A G E N D A

Architectural Review Board

October 25, 2022 – 5:30 p.m.

SUBJECT: Request for approval of demolition of two historic structures, tree removals, grading, and construction of a gas station inclusive of a convenience store, canopy, signage, and landscaping, for the properties located at 204 N. Holt Street, 637 Clay Street, 638 Herron Street and a portion of parcel 11 01 12 3 011 001.000 between Herron and Clay Streets (Cottage Hill).

Design Evolution

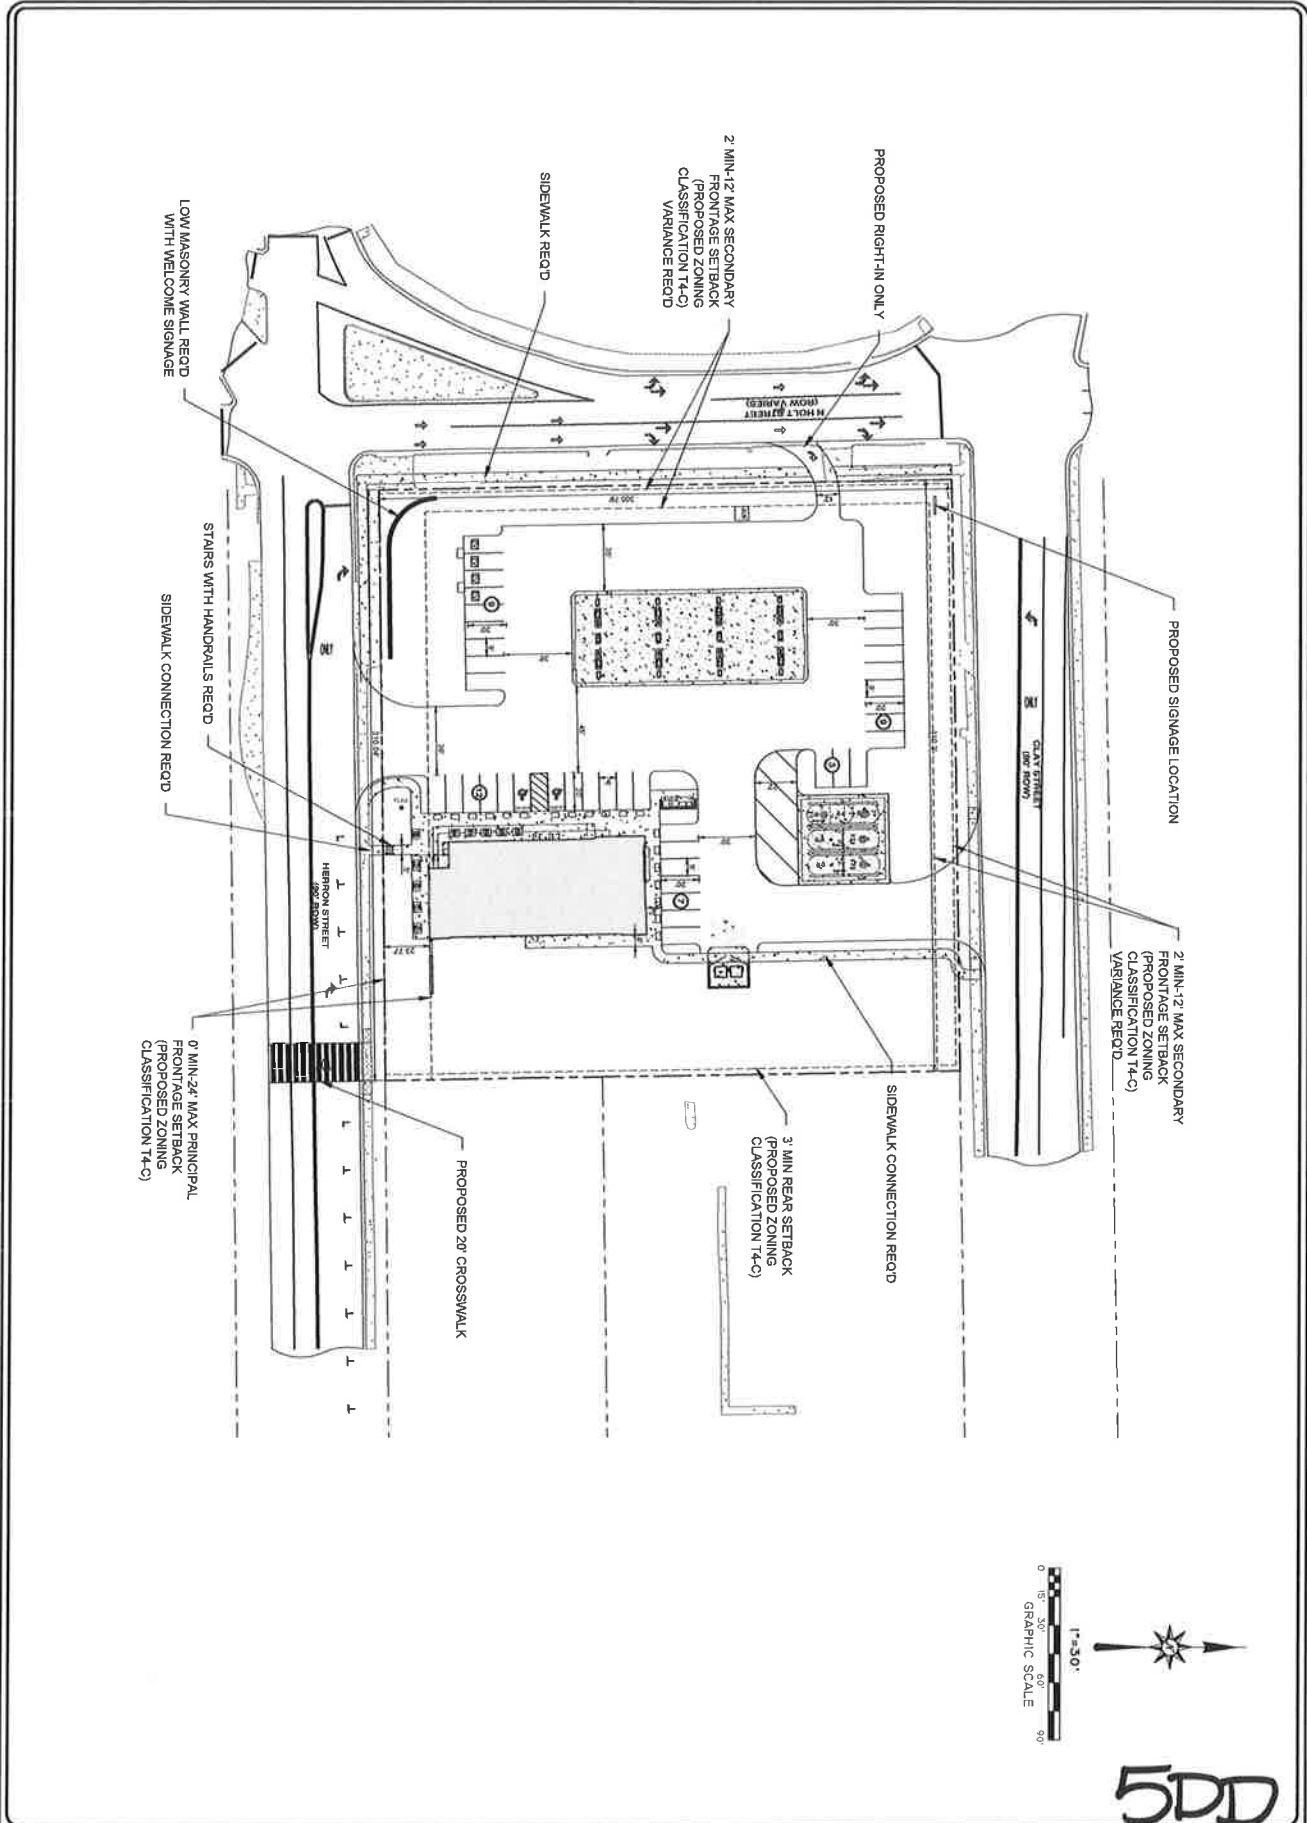
- Absent any other building setbacks to conform with on these frontages, following the SmartCode guidelines for principal frontages and building disposition, this proposal does not entirely meet the standards set forth above. Permeability at street level of the principal frontage needs to be 70% glazing (5.5.5e), which appears to be addressed in this iteration. See sheet 5CC.2 for the evolution of the submission summary.

- ADD PATIO AREA ALONG HERRON FRONTAGE FOR PEDESTRIAN ENGAGEMENT
- COORDINATE WITH CITY TO ADD A PEDESTRIAN CROSSING AT HERRON ST TO CREATE SAFER CONDITIONS FOR CROSSING HERRON

- BUILD NEW SIDEWALKS ALONG PORTIONS OF HERRON ST AND HOLT ST TO PROMOTE PEDESTRIAN CIRCULATION AROUND BLOCK. CONNECT CLAY TO STORE WITH SIDEWALK
- ADD MASONRY WALL WITH WELCOME TO COTTAGE HILL SIGNAGE

- MOVE TANKS TO NORTH SIDE OF THE PROPERTY
- MOVE THE DUMPSTER ENCLOSURE TO OPPOSITE SIDE OF BUILDING, AWAY FROM HERRON ST
- PROVIDE ENHANCED LANDSCAPING ALONG SOUTHWEST CORNER OF SITE PER NEIGHBOR REQUESTS TO LIMIT VIEWS TO UNDER CANOPY

- ELIMINATE ACCESS DRIVE AROUND BUILDING TO WORK MORE COHESIVELY WITH EXISTING TOPOGRAPHY
- CONCENTRATE ALL DETENTION AT SOUTHWEST CORNER OF LOT TO CREATE MORE LANDSCAPE BUFFER BETWEEN HERRON AND CANOPY

HERRON ST FOCUSED FACADE OPTION

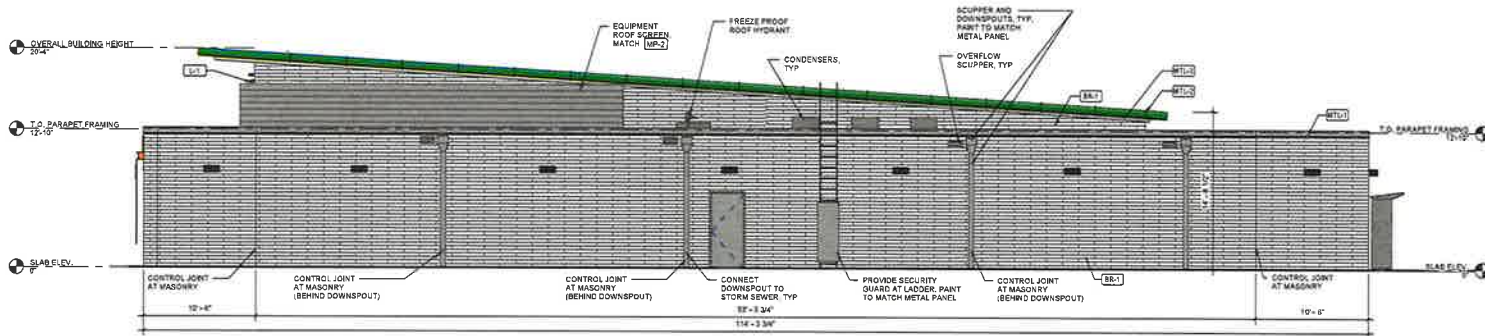
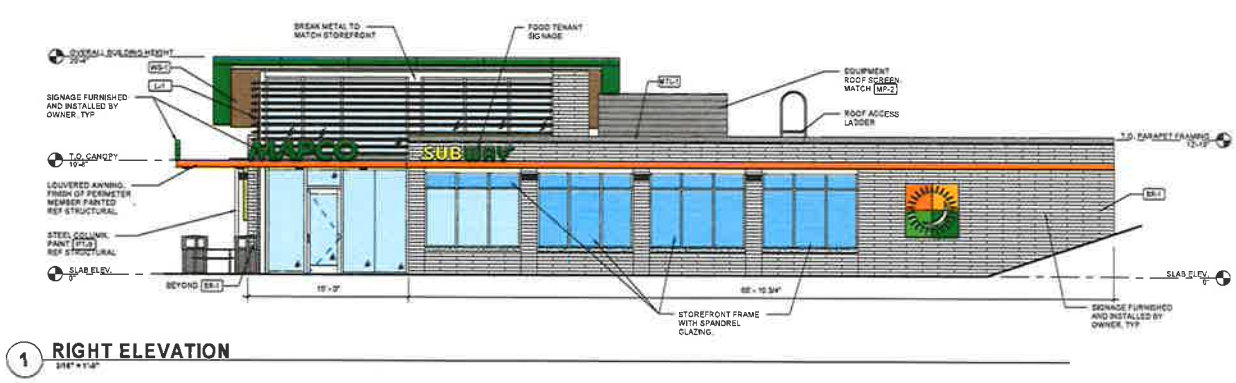
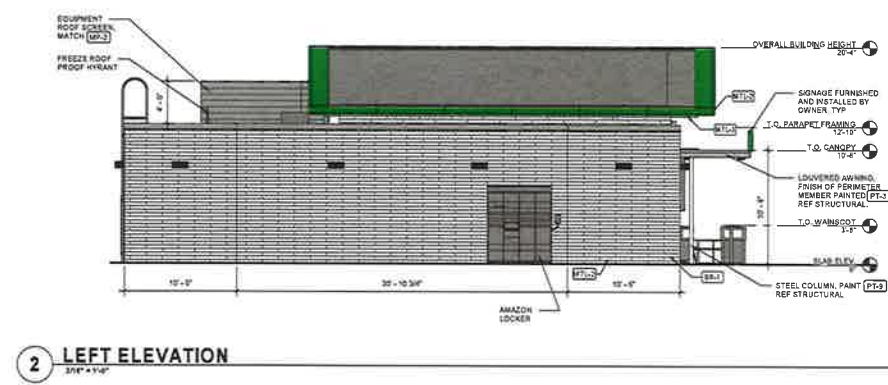
- As to the building design itself, a revised submission includes the use of a stone veneer system to emulate a masonry “brick” (see Exterior Finishes). The design is

modern, but is similar to another mid-century building (c. 1964) on the next block. It is noted that this “end” fronts the street, but it is on a narrow interior lot. Most of the commercial/industrial buildings between N. Holt and N. Goldthwaite are brick or concrete block.

- Is a masonry panel a sufficient facsimile to a concrete block or brick?
- Is the design too modern? Would a more traditional storefront building be better suited for this location, more closely emulating the building that demolition is being requested for?
- MAPCO gas stations have been “dark sky” compliant.
- The Board has followed the City’s Landscaping requirements to screen large expanses of pavement and tree replacements. In T4-C, a street screen is required, vegetative screening follows the Landscape Ordinance.
